<b>Project Name:</b>	Land at the Former Sipson Garden Centre, Sipson
<b>Document Reference:</b>	507.0010/HRN/2
<b>Document Name:</b>	Highways Response Note
<b>Prepared By:</b>	Izzie Drohan (April 2024)
<b>Checked By:</b>	Caitlin Turley (April 2024)
<b>Approved By:</b>	Kim Hammonds (April 2024)

1.1 This Highways Response Note (HRN) has been prepared by Paul Basham Associates on behalf of Bidwells to address highways comments received by both London Borough of Hillingdon (LBH) and the Greater London Authority (GLA) in relation to a planning application submitted (under planning ref: 67666/APP/2023/3721) for a B2 use class development comprising a specialist vehicle servicing site totalling 1,450sqm at the Former Garden Centre, Sipson Road, Sipson. The site location is shown below in **Figure 1**.

Ground floor plan

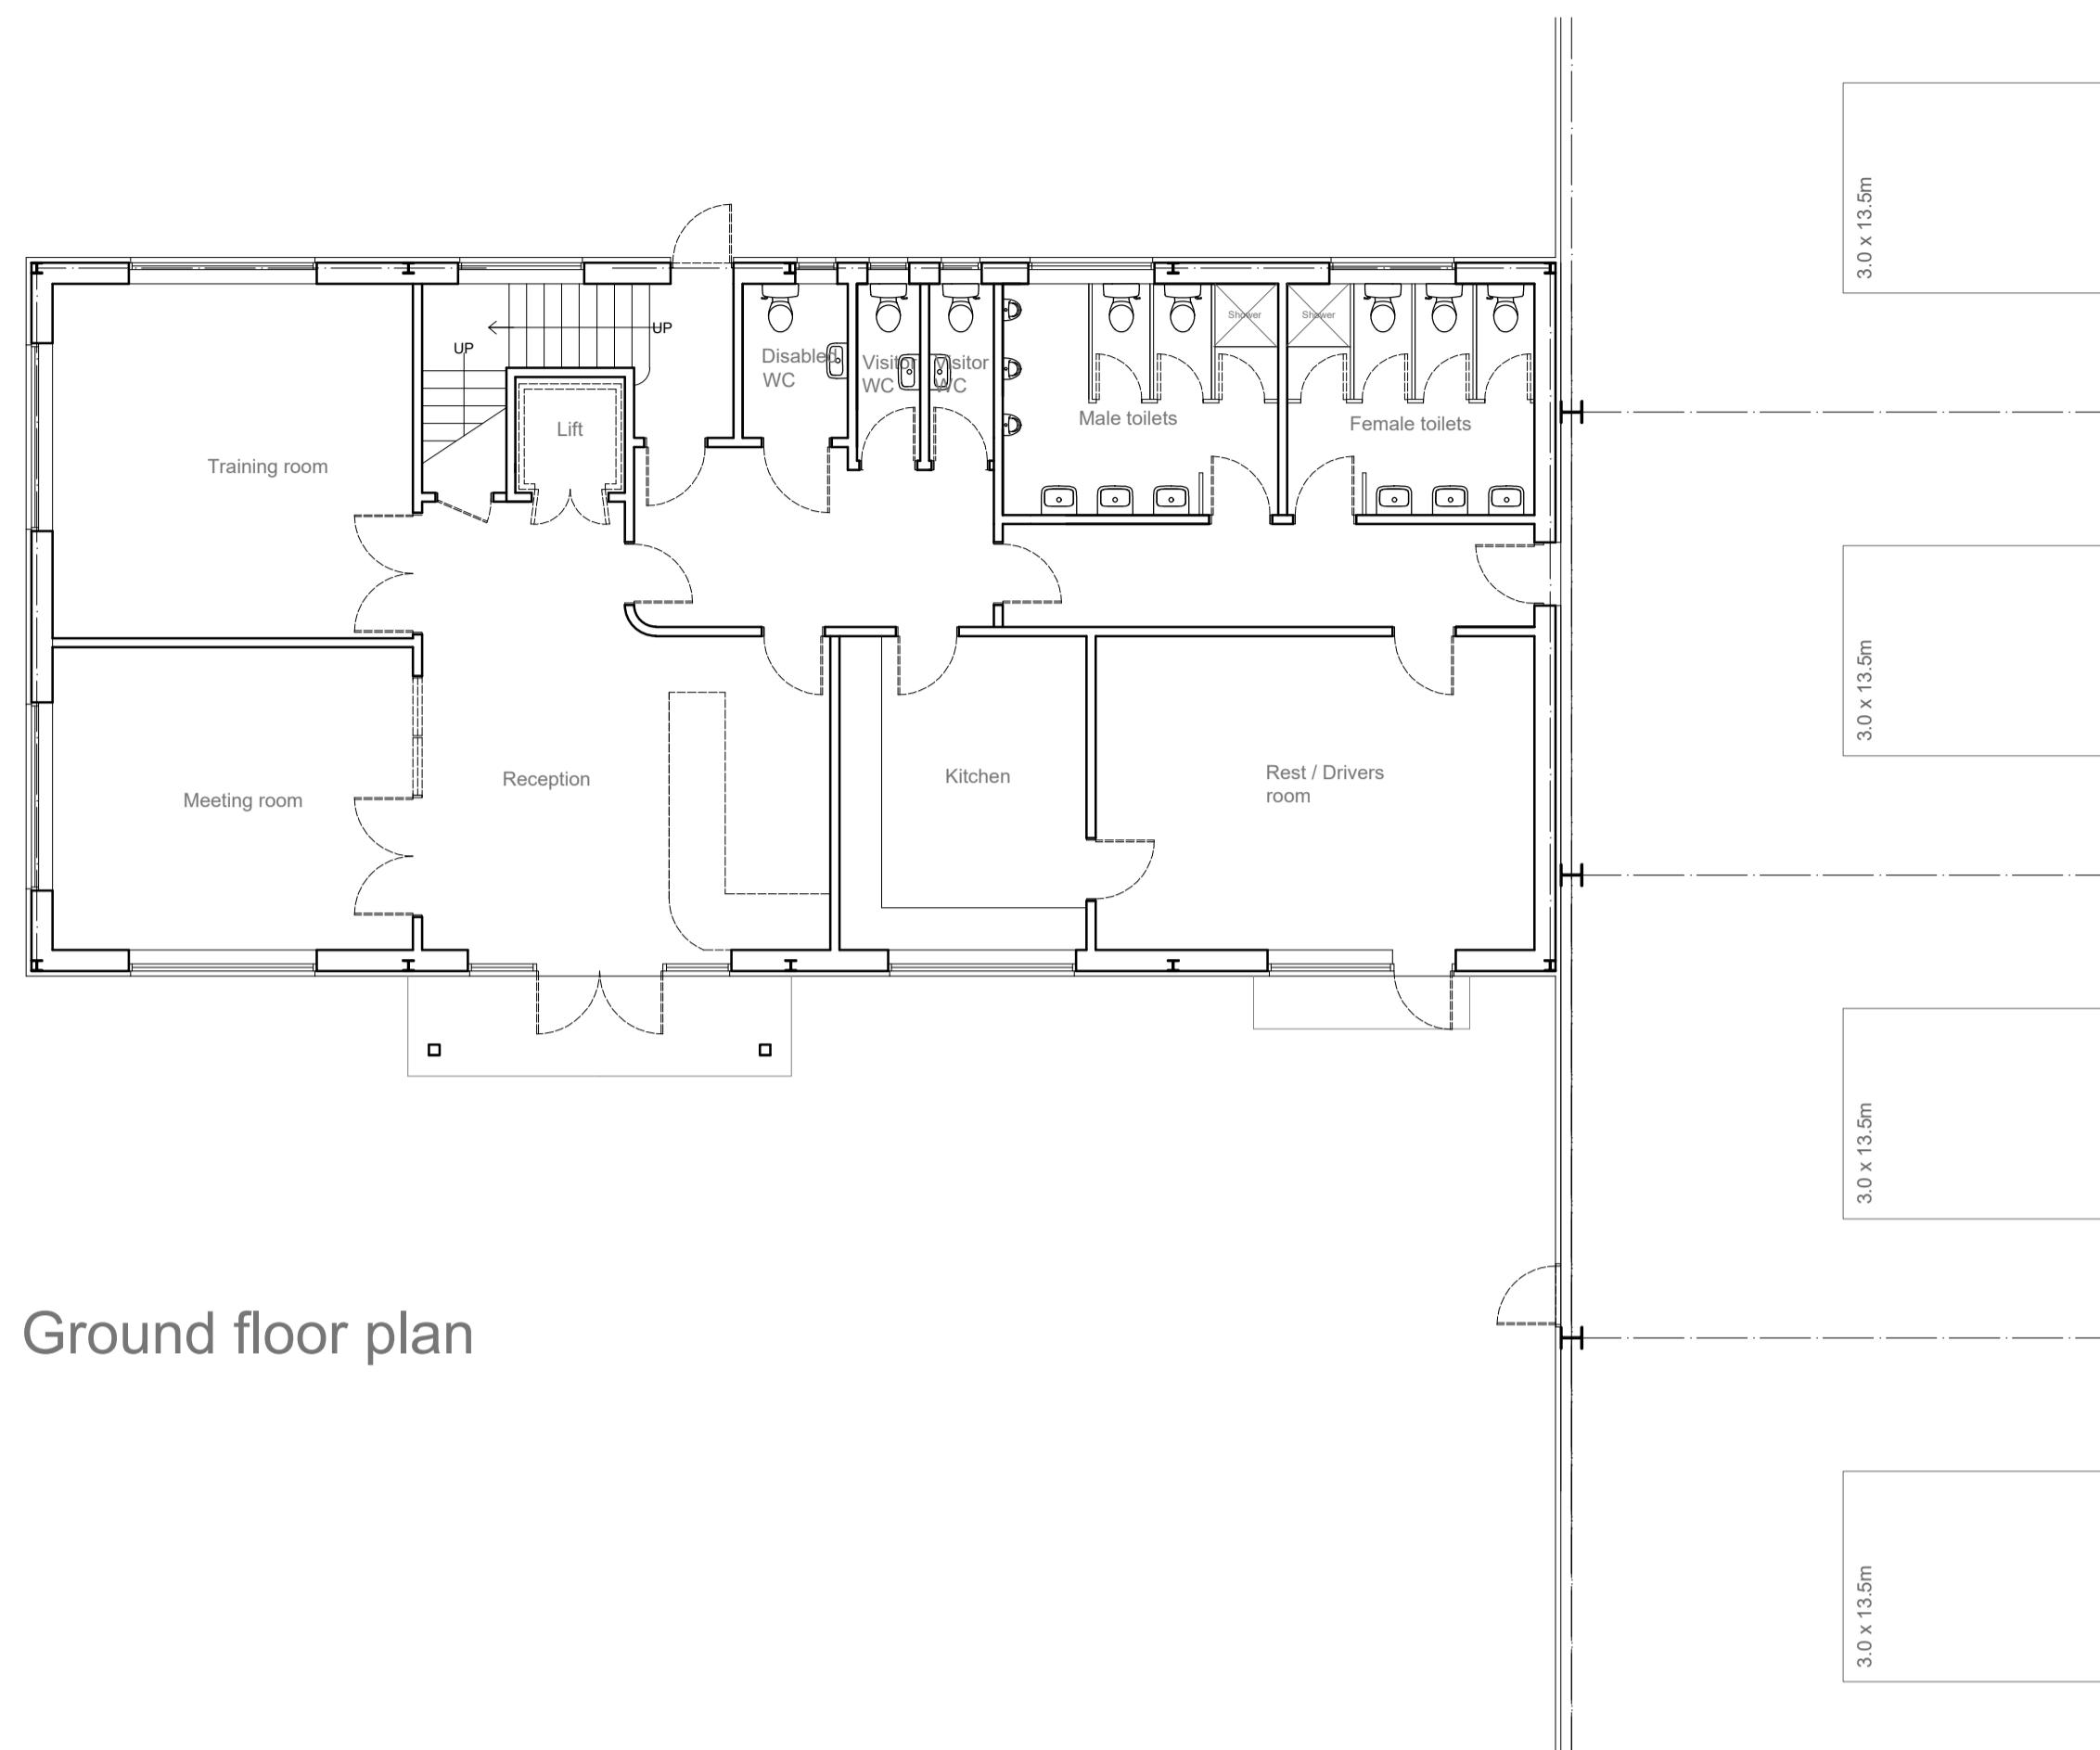
4.1 The GLA requested that “*cycle parking should be secured, covered and be designed in line with the London Cycle Design Standards (LCDS). Shower and changing facilities for staff should be also be provided for employees to comply with London Plan Policy T5*” whilst LBH advised that revised drawings (related to cycle parking) should be submitted for approval.

4.2 Therefore, in order to address this, the proposed cycle store will be secured and covered. Furthermore, one female and one male shower will be provided within the changing facilities within the employee building and is marked on the site layout, attached within **Appendix D**.
